UNITED STATES PATENT AND TRADEMARK OFFICE

10/675,206

Office Action Summary	Application No. 10/675,206	Applicant(s) ONDE ET AL.	
	Examiner Hanh Phan	Art Unit 2613

DETAILED ACTION

Fig. 3
Prior Art

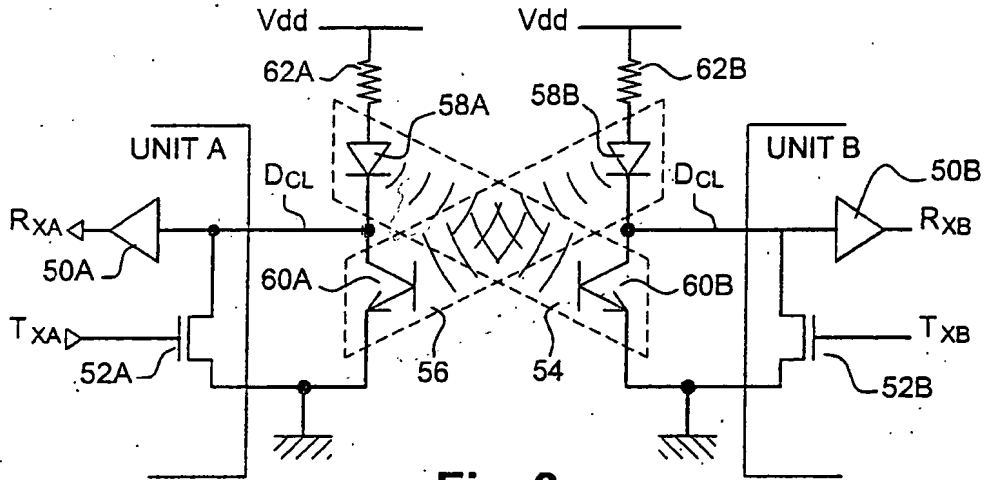
5. Claims 1, 14-17 and 26 are rejected under 35 U.S.C. 103(a) as being unpatentable over Prior Art Figure 3 in view of Riley (US Patent No. 6,750,463).

Regarding claims 1 and 17, Prior Art Figure 3 teaches an optical coupling device operative over a bidirectional data link between at least first and second communicating units (i.e., first communicating unit A and second communicating unit B), each operative to send and receive data along a common wire of the data transmission link, the device comprising:

at least first and second optical coupling means (i.e., a first optical coupling means comprises a photon flux source 58A and a photon flux detector 60A and a second optical coupling means comprises a photon flux source 58B and a photon flux detector 60B), each comprising a photon flux source and a photon flux detector, wherein:

the photon flux source of the first optical coupling means (i.e., LED 58 A) is commanded in response to a data transmission by the first communicating unit, the photon flux source of the second optical coupling means (i.e., LED 58B) is commanded in response to a data transmission by the second communicating unit,

the photon flux detector of the first optical coupling means (i.e., photo flux detector 60A) is operative to produce a signal on the data transmission link at the first communicating unit in response to a command of the photon flux source of the second optical coupling means from the second communicating unit,

the photon flux detector of the second optical coupling means (i.e., photon flux detector 60B) is operative to produce a signal on the data link at the second communicating unit in response to a command of the photon flux source of the first optical coupling means from the first communicating unit.

The Prior Art Figure 3 differs from claims 1 and 17 in that it fails to teach first inhibiting means for inhibiting the photon flux source of the second optical coupling means in response to an activation of the photon flux source of the first optical coupling means, and second inhibiting means for inhibiting the photon flux source of the first optical coupling means in response to an activation of the photon flux source of the second optical coupling means. Riley, from the same filed of endeavor likewise teaches an optical isolation device (Figures 2-4). Riley further teaches first inhibiting means for inhibiting the photon flux source of the second optical coupling means in response to an activation of the photon flux source of the first optical coupling means, and second inhibiting means for inhibiting the photon flux source of the first optical coupling means
